#### Project: IEEE P802.15 Working Group for Wireless Personal Area Networks (WPANs)

Submission Title: [Questions/Comments on AV-OFDM MAC]

Date Submitted: [April 21, 2008]

Company [National Institute of Information and Communications Technology (NICT)]

### Comments for AV-OFDM (related to frame) (2/2)

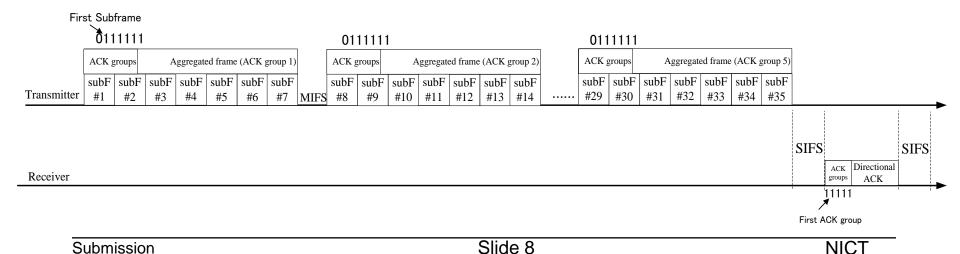
- Comment 4: Is the data rate of association/disassociation frame the same to that of beacon frame?
- Comment 5: What data rates for ACK frames of Imm-ACK, Dly-ACK, Imp-ACK and Blk-ACK are used in CAP and CTAP?
- Comment 6: For omni LRP frame, the data rates of MAC header, HCS and Payload is defined in LRP mode index of LRP header (DF2). Do MAC header, HCS and Payload have the same data rate?
- Comment 7: What data rate is used for HRP header?
